The Hows, Whys and Fixes for Pegasus "Jitter"

Recent investigations into the reasons and possible cures of Pegasus screen Jitter have revealed that there are at least 4 distinct causes. This report explains the theory behind these causes and suggests some modifications to erradicate the jitter.

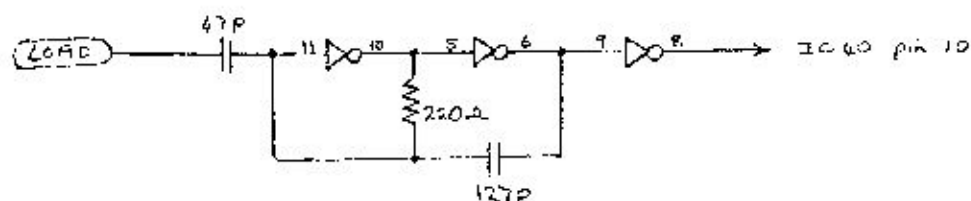
The frame rate for the video is initiated by a signal derived from the mains; Once the frame is started, everything is locked to the processor clock. So while the picture information doesn't jitter with respect to HSYNC and VSYNC, the frames themselves do jitter with respect to each other. In other words the VSYNC signals are not regular. Sometimes they are $X \times 64 \text{ us}$ (HSYNCS occur every 64 us) apart and sometimes they are $(X + 1) \times 64 \text{ us}$ apart. Normal TV sets have an oscillator which likes to lock to regular VSYNC pulses. It will infact lock to a frequency with a period somewhere between $X + 1$ and X times 64 us . Then what you get is a picture sometimes slightly above and sometimes slightly below the true position. The cure is to use some kind of divider to derive your 50Hz from the processor clock, instead of the mains. The following mod uses one IC and some existing gates on the Pegasus board.

The 74LS20 gate has tracks running to it which must be cut.
 The 74LS04 becomes free from a modification to the dot clock
 oscillator which was given to us by G. Barbour of Christchurch.
 This modification stops shimmer on the displayed characters
 and stabilizes the oscillator frequency.

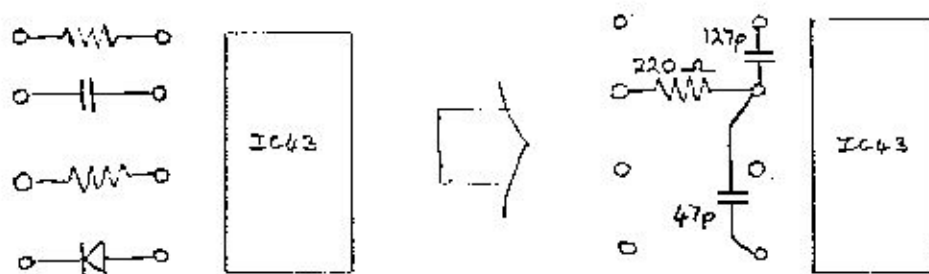
This modification only involves removing 4 components and
 replacing them with 3 components as shown.

The IC43 gate at pins 13 and 12 is freed for use in the
 4020 mod.

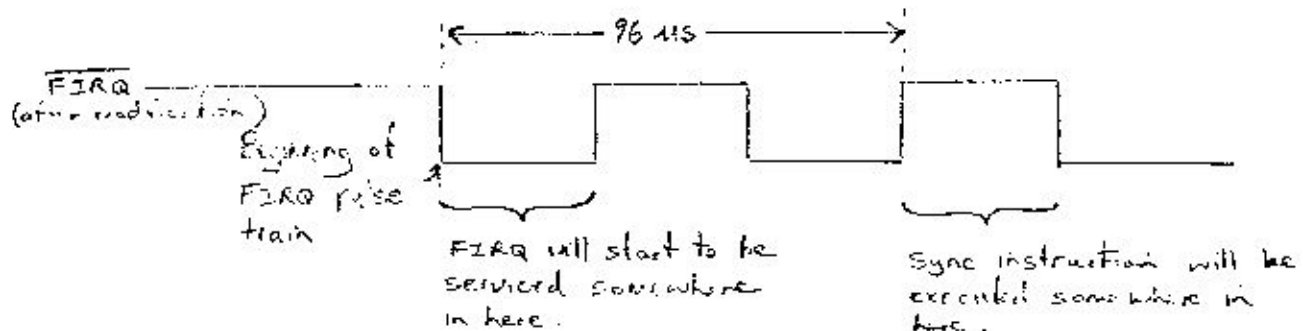
The FIRQ pulses generated by the existing Pegasus hardware are 8 μ s long. The 6809 chip however only checks the FIRQ pin after each instruction. Since 6809 instructions can take up to 20 μ s it is clear that it is possible for the chip to miss on FIRQ pulse. If it "sees" the following one then the whole picture will be 64 μ s too late i.e. one scan line too low on the screen. This causes jitter whenever programs with longish instructions are running.

The cure for Type 2 jitter is to take the FIRQs from the 74LS93 divider, IC7 pin 9. This is a square wave with 32 μ s each way. This modification also needs a new monitor version 2-3. The delays in this monitor are adjusted so that a) the picture is in the middle of the screen and b) the SYNC instruction is 96 μ s after FIRQ starts to be serviced. This ensures that the SYNC instruction is not executed while the FIRQ line is low, which would cause terrible sideways jitter.

The actual modification is done by cutting the track to the 74LS32 pin 5 and jumping this pin to the 74LS93 pin 9 (IC7) and getting a version 2-3 monitor.

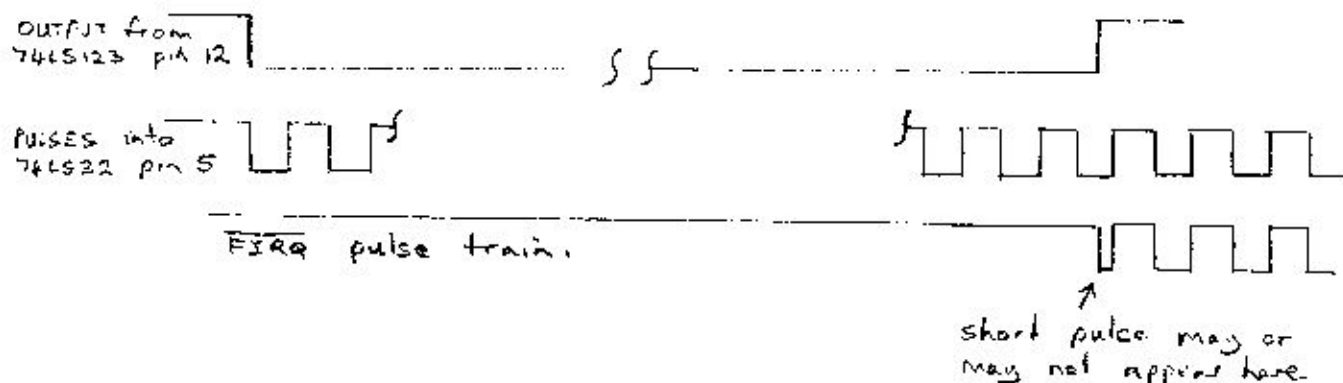
From this drawing it can be seen that 32 μ s is the ideal length for the FIRQ pulse (which is active low) because it gives an equal mark space ratio square wave. If the FIRQ pulse were any longer, then the period in which the FIRQ line is high becomes correspondingly shorter and it is then possible for the SYNC instruction to occur while the FIRQ line is low, giving sideways jitter.

If the FIRQ pulse is shorter than 20 μ s it is possible for them to be missed by the processor. In fact the full 32 μ s is better because it allows the programmer to mask off FIRQs for two or three instructions if he wishes, without missing an FIRQ.

So 32 us FIRQs are used. The time from the start of servicing of the FIRQ to the SYNC instruction in the monitor is adjusted to be 96 us. Also since the new FIRQs are out of phase with the old ones, the monitor has its delay that positions the picture in the middle of the screen adjusted.

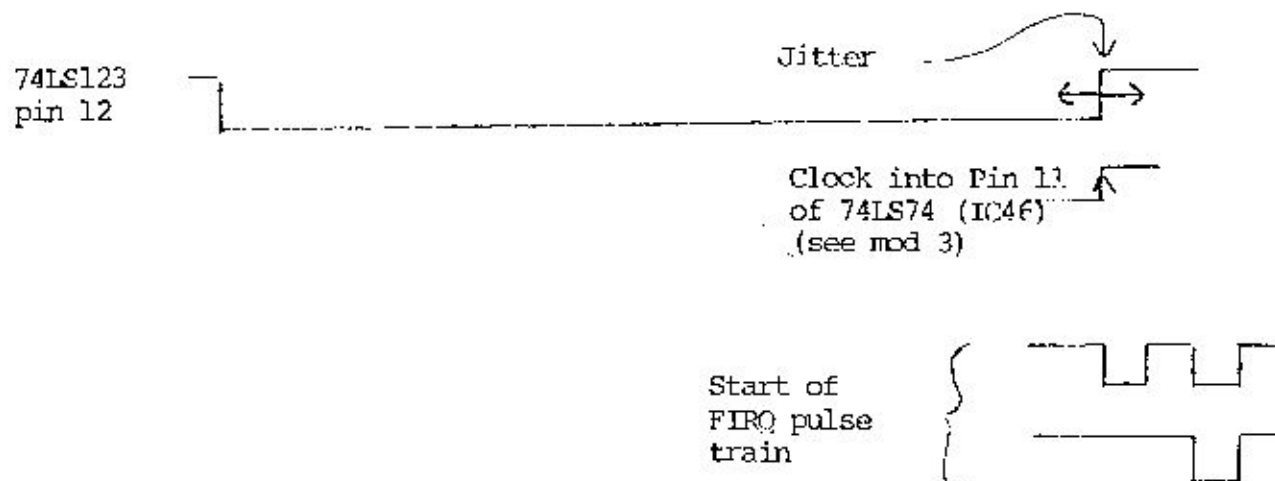
The timing from the VSYNC pulse to the start of the FIRQ burst of pulses is done by a 74LS123 one-shot. The delay is approx 3 ms, and since this is timed from an R-C network it cannot be set accurately. If the end of the delay comes during the time that the FIRQ pulse is low, then a small FIRQ pulse will be given to the processor before the burst of full length ones.

Since the pulse can be very short the processor may or may not "see" it. The 123 delay drifts with time and so the jitter will come and go.

The cure is to clock IC46 b with FIRQ pulses instead of E. This F/F is redundant as it is anyway. The existing track to the 74LS74 pin 11 (IC46) cannot be cut as it is underneath the IC. Instead it must be cut in two places and then 2 jumpers need to be put in.

Cut the track running from IC46 pin 11 to the system PIA pin 25 and also cut the track running from IC46 pin 11 just before the hole where it goes through the board and on to pin 3 of the 74LS04 oscillator. (IC43). Now join this hole back to the PIA pin 25. Now join IC46 pin 11 to the 74LS32 pin 5 (IC2). Note that this half of IC46 does not appear in the drawings but it is used in the circuit.
